SERVICE BULLETIN 126:

SUBJECT: G-III Main Landing Gear Strength Upgrade

APPLICATION: All G-IIIs kits shipped prior to December 1993 that have main landing gear serial numbers up-to but not including #263 (gear strut serial numbers are located on the top surface of the trunnion cylinder).

FIGURE (1)

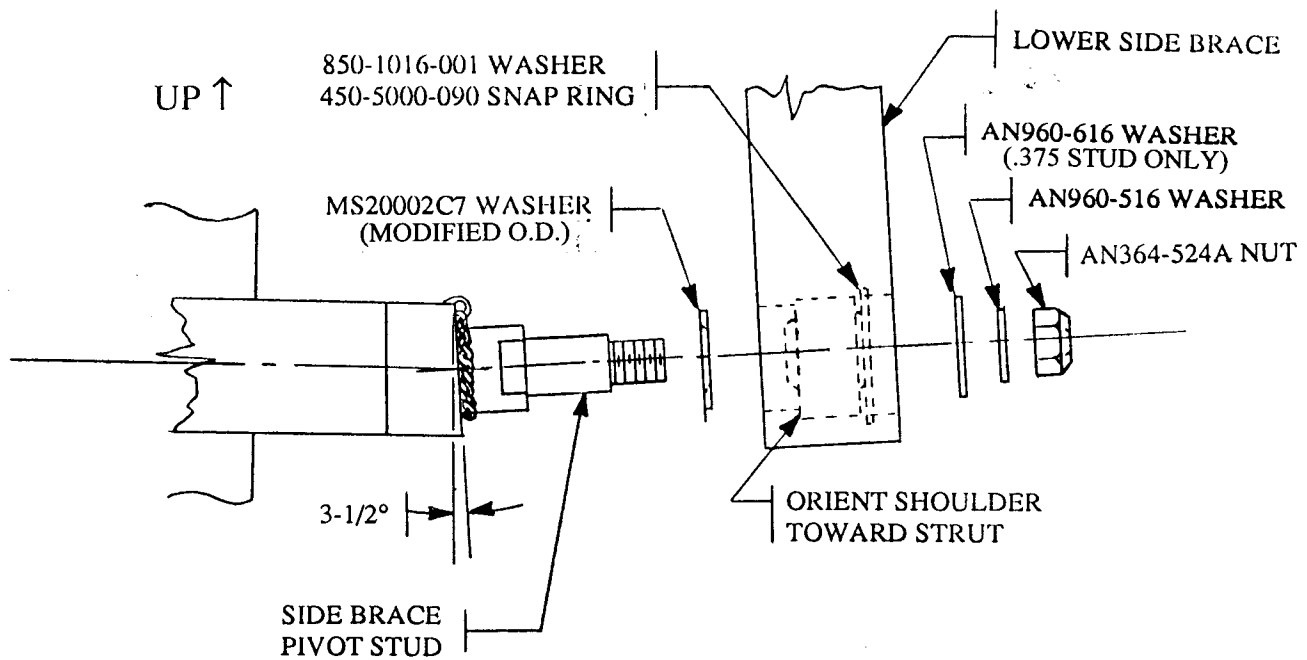
Upgrade #1: Heavy Duty Main Landing Gear Trunnion Side Brace Stud

The existing side brace attach point on the main gear is a welded-in stud with a diameter of .375" in the area of the bearing shoulder. The heavy duty side brace stud is a separate, machined unit with a shoulder diameter of .435" and provides 150% additional strength.

To upgrade to the heavy duty side brace stud, the original stud must be cut off and the side brace saddle machined to a 3 1/2° angle. An existing side brace stud pilot hole (.510 Ø) needs to be drilled and tapped for 5/8-18 thread. A lockwire hole (3/32 Ø) should be machined at a convenient location. All affected machined surfaces will then need to be primed.

NOTE: These heavy duty side brace studs require the use of the Heavy Duty G-III Side Braces (353-5205-103 and 104) and Down Lock Component Kits (353-5290-501). The heavy duty side brace arms are sized to use larger bearings for the trunnion attach points. These bearings have an internal ID of .437" to coincide with the shoulder of the new replaceable trunnion stud. These side braces also have an increased cross sectional area to brace the main gear against side loads that may be encountered. If not already installed, these parts can be purchased from our order desk. If the G-III Emergency Gear Ext. Retrofit Kit (353-5800-502) has been installed, then the Heavy Duty Side Brace and Down Lock assemblies have also been installed because of the requirement to use the heavier side braces for this installation. In this case a bushing would have been used to adapt the heavy duty side braces to the existing smaller diameter trunnion studs.

FIGURE (2)

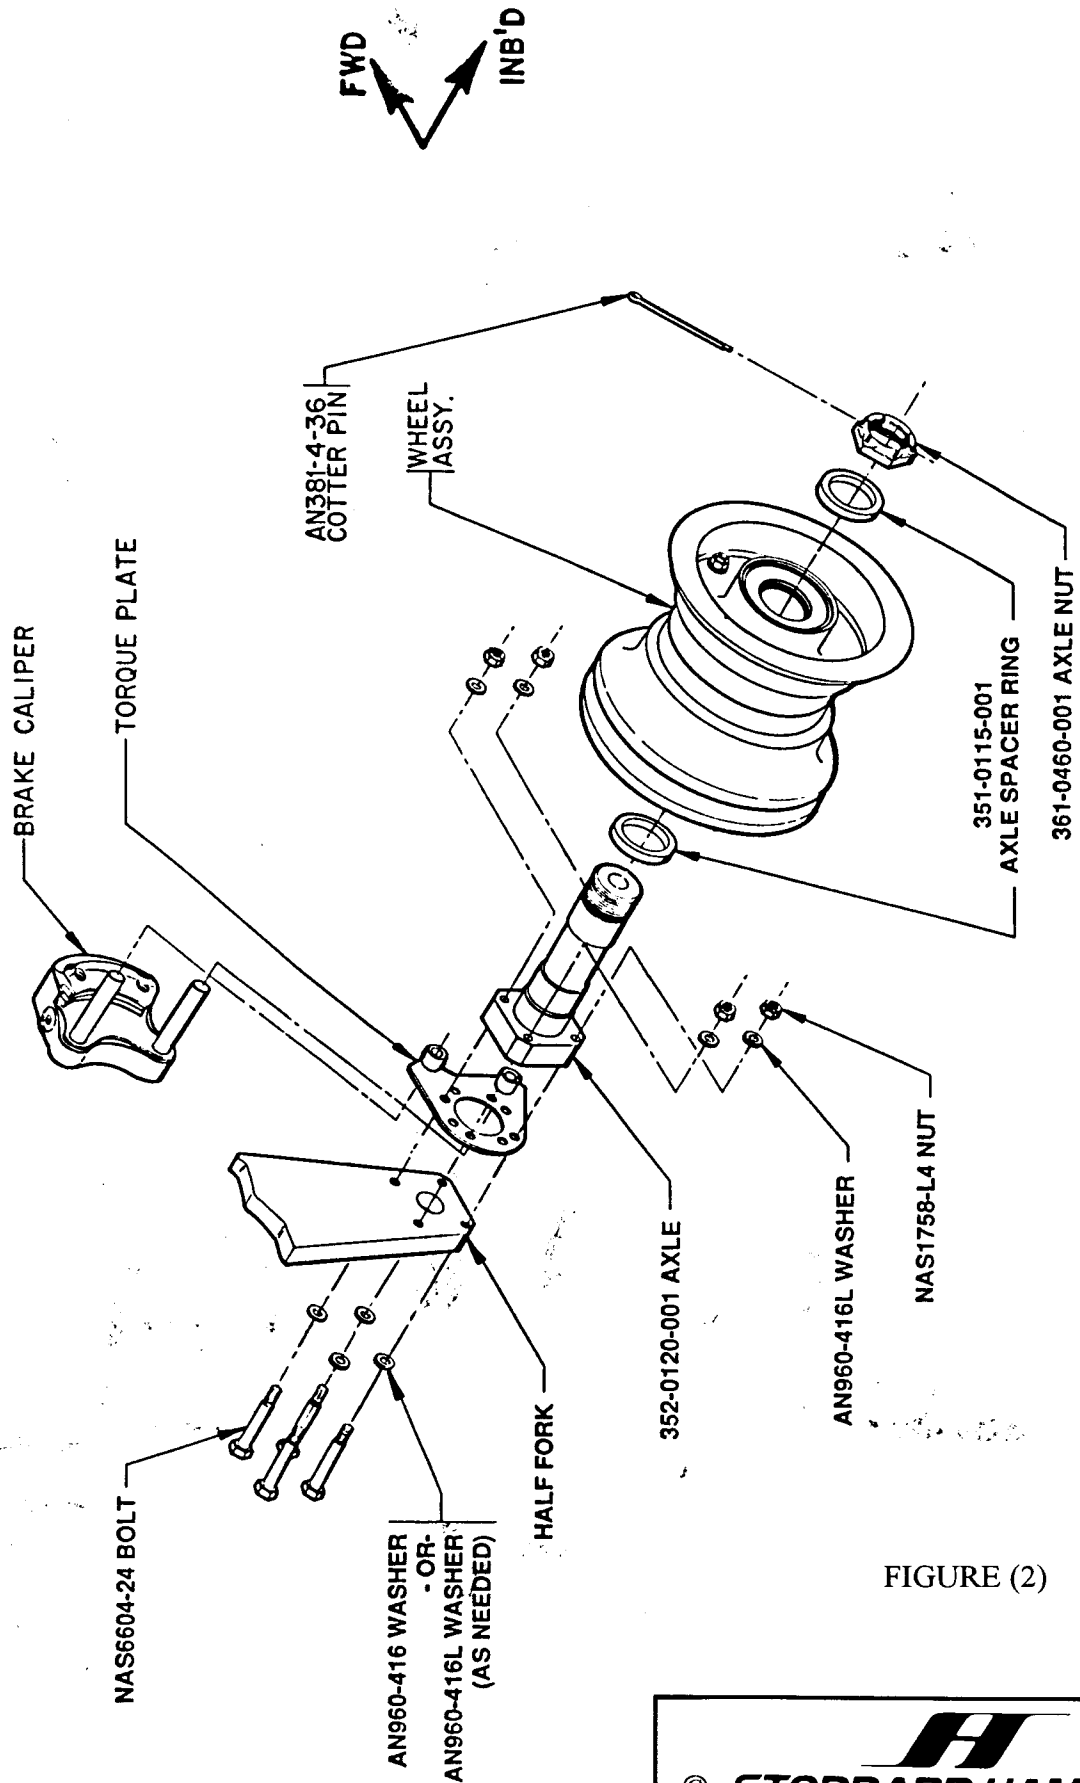
Upgrade #2: High Strength Axle Securing Bolts

The part number for the original bolts used to secure the axle to the half fork is: AN4H13A. Because these bolts can be subjected to high tension and shear loads during hard landings or obstacle impact at high gross weights, we recommend that these bolts be upgraded to NAS6604-24s. These bolts provide 30% additional increase in strength to this joint for operation at the higher gross weights. To install them, it will be necessary to drill out the existing .250" diameter threaded holes for through bolts. The new NAS bolts will no longer screw into threads in the half fork, but will be secured by high strength NAS1758-L4 nuts.

One of our builders informed us that the brake caliper torque plate can be mounted in place of the axle spacer plate (#363-5121-001) between the half fork and the axle. This requires rotating the torque plate so that the bushings are pointed inboard, as shown in Figure (2). This orientation gives better bushing engagement onto the caliper pins and eliminates the spacer plates. The NAS6604-24 bolt length is sized for this configuration.

In order to install the higher strength NAS6604-24 bolts, remove the existing AN4H13A bolts connecting the axle to the half fork. Drill out the threads with a .250" dia. drill. After each hole is drilled, prime the bare metal inside each hole with an epoxy primer. Install the torque plates and axles using the NAS6604-24 bolts, AN960-416L washers, and NAS1758-L4 nuts as shown in Figure (2).
